UNITED STATES PATENT AND TRADEMARK OFFICE

APPLICATION NO.	FILING DATE	FIRST NAMED INVENTOR	ATTORNEY DOCKET NO.	CONFIRMATION NO.
10/699,642	11/04/2003	Alex Hornig	HORN3170/EM	5376
23364	7590	03/11/2005	EXAMINER	
BACON & THOMAS, PLLC 625 SLATERS LANE FOURTH FLOOR ALEXANDRIA, VA 22314			EDGAR, RICHARD A	
			ART UNIT	PAPER NUMBER
			3745

Office Action Summary	Application No. 10/699,642	Applicant(s) HORNG ET AL.	
	Examiner Richard Edgar	Art Unit 3745

DETAILED ACTION

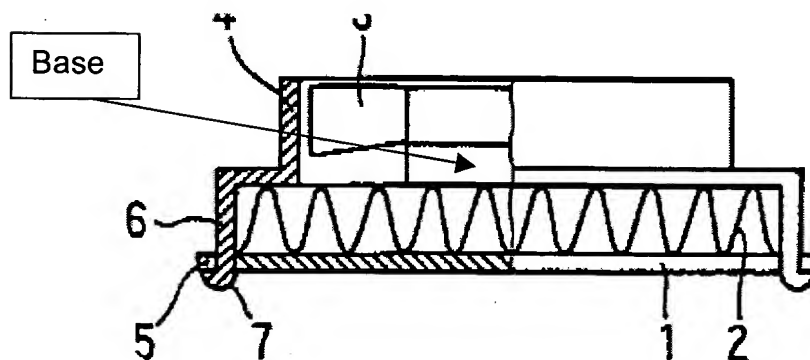
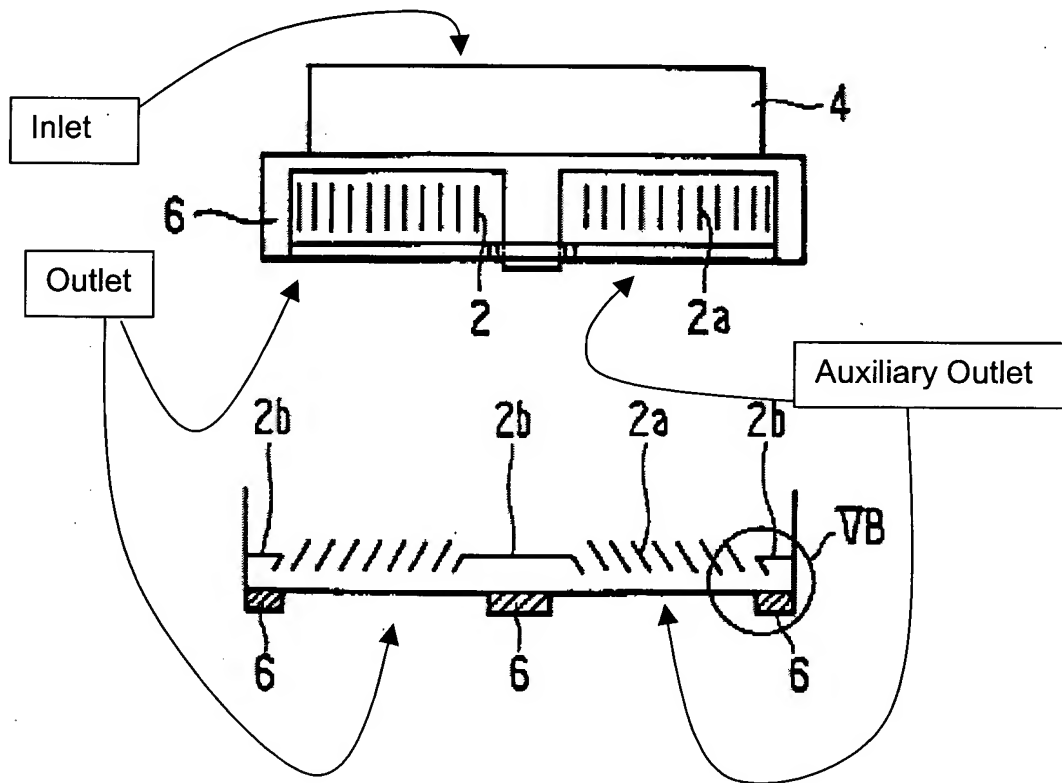
Yamaguchi et al. disclose in Figs. 3-5, an airflow guiding structure for a heat dissipation fan, comprising: a housing 4, 6 provided with an air inlet and an air outlet; a base mounted in the air outlet for supporting a fan wheel 3 which forms with a plurality of blades; at least one auxiliary air outlet formed on the housing proximate the air outlet;

and a plurality of air guiding members 2a arranged in the air outlet and inclined to the axis (radial axis, for instance) of the housing, the auxiliary air outlet being adjacent to the guiding members; wherein when the fan wheel rotates, the guiding members deflect airflow to constitute at least two airflow directions at the air outlet and the auxiliary air outlet. See annotated Figures below.

Regarding claim 2, the outlet and auxiliary outlet are connected, as seen in Figure 3, by part of the housing 6.

With respect to claim 3, the guiding members 2a are straight.

As for claim 6, the Yamaguchi et al. reference shows a supporting rib 2b with a vertical width and axial orientation.

Regarding claim 7, the guiding members 2a, which form member 2b, constitute an inverted "V" section (see Figure 5A). Furthermore, Figure 4 shows that the examiner identified supporting base (annotated Fig. 4) is supported by the guiding members 2.

The guiding members 2a are shown regularly inclined.
